Verification Report

- 1ST PERIODIC –

**YUNNAN HONGTA CEMENT WASTE HEAT RECOVERY
POWER GENERATION PROJECT**

Report No: 8000404662 – 11/591

The electrical connection diagram in registered PDD is as below:

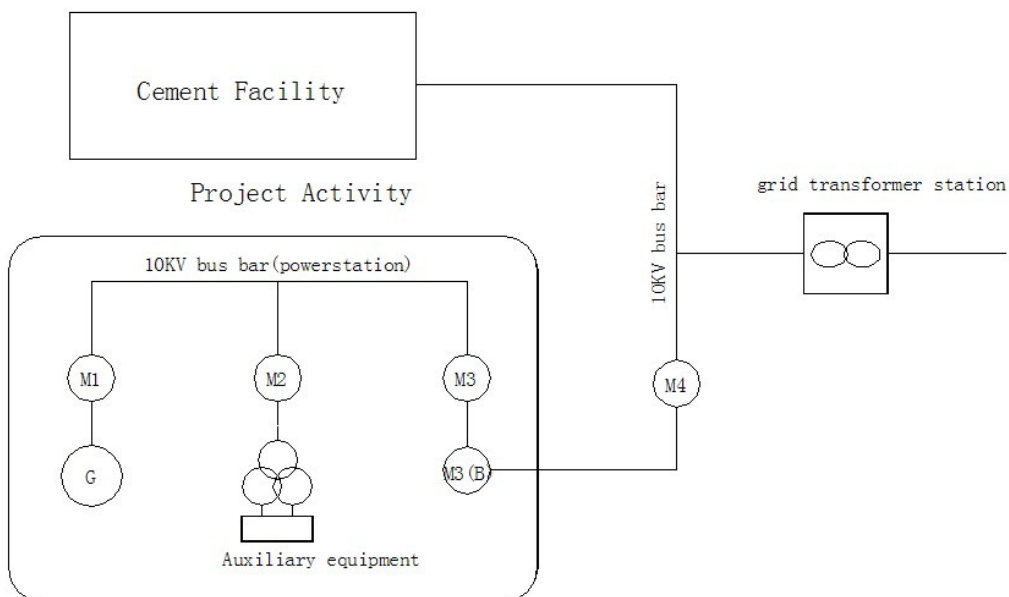
$EG_{pj \text{ to grid}, y}$: Electricity quantity supplied to the project from the grid	$EG_{pj \text{ to grid}, y}$: Net electricity supplied to the cement production line connected to the grid
M3 (B), measure the electricity supplied to the cement production plant ($EG_y/Q_{OE,y}$), will be installed on site.	M3 (B), is the backup meter of meter M3.
In the electrical connection diagram, M3(B) was parallel circuit with meter M3.	The wiring diagram is changed. The location of meter M3 and M4 changed from the grid connection line to a point before the grid connection. The location of backup meter M3 (B) changed from parallel circuit with meter M3 in the registered PDD to serial circuit.

The post registration changes mentioned above are about corrections of project information and the location change of the meters that do not affect the design of the project activity and will be more clear and transparent, so they do not require prior approval by the Board as per the Clean Development Mechanism Project Standard (version 01.0) in EB 65 Report Annex 5. The post registration changes reflect the actual project situation more transparently which have been confirmed in the Power Wiring Diagram ^{/PWD/} and Approval of Grid Connection ^{/AGC/}. The
